UNITED STATES
DEPARTMENT OF THE INTERIOR
BUREAU OF LAND MANAGEMENT

SUNDRY NOTICES AND REPORTS ON WELLS
Do not use this form for proposals to drill or to re-drill an abandoned well. Use form 3160-3 (APD) for such proposals.

8. Well Name and No.
WOOLLEY FEDERAL 6

Permanent Abandonment of Federal Wells
Conditions of Approval (LPC Habitat)

** BLM REVISED **

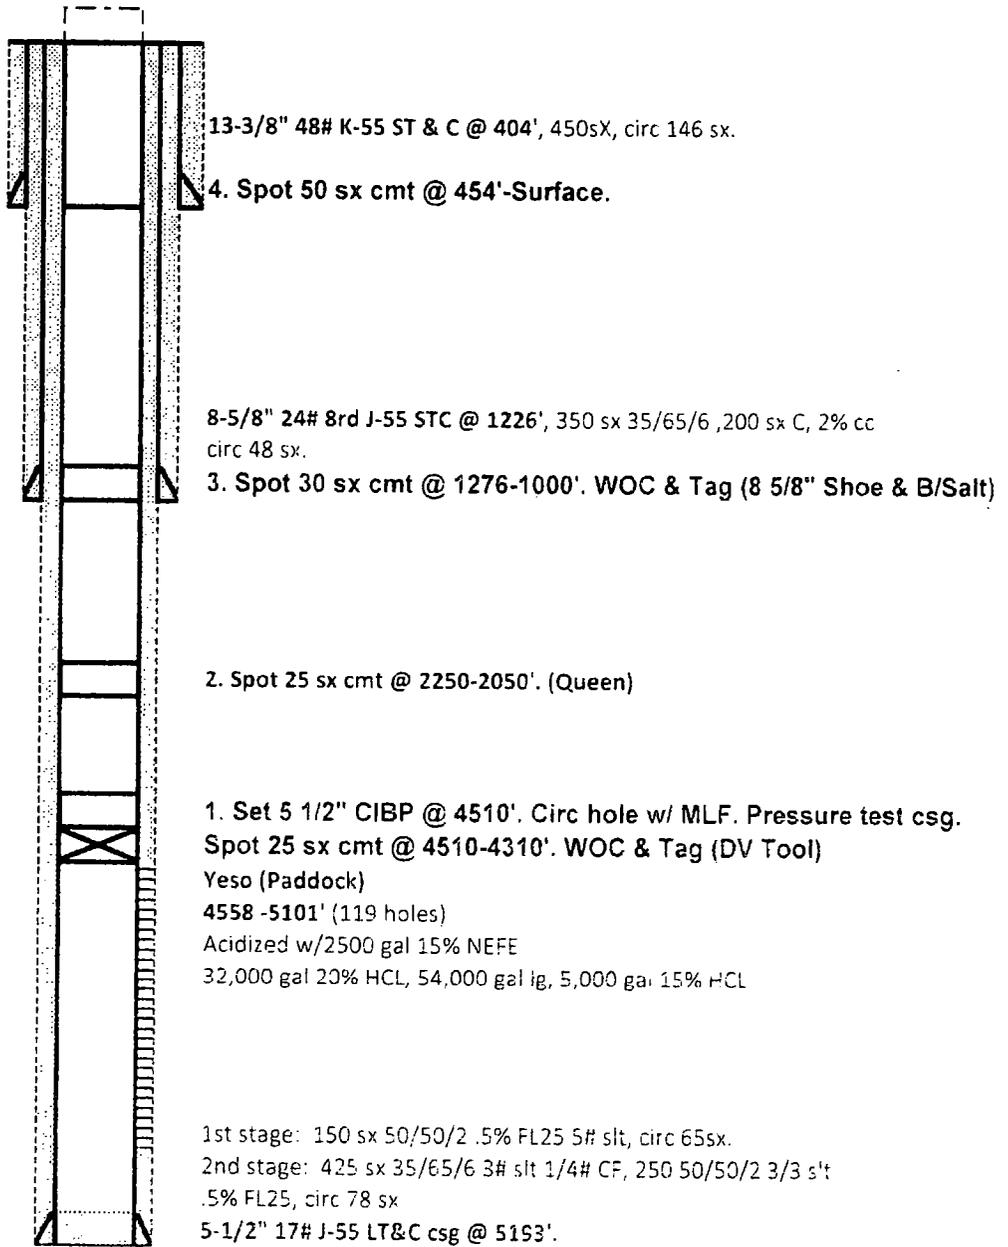
- Set 5 1/2" CIBP @ 4510'. Circulate hole w/ MLF. Pressure test csg. Spot 25 sx cmt @ 4510-4310'. WOC & Tag (DV Tool)
- Spot 25 sx cmt @ 2250-2050' (Queen) 3046 - 2900 (San Andrus)
- Spot 30 sx cmt @ 1276-1000'. WOC & Tag (8 5/8" Shoe & B/Salt)
- Spot 50 sx cmt @ 454'-Surface. 522
- Cut off well head, verify cmt to surface, weld on Below Ground Dry Hole Marker.

Below ground level dry hole marker required.
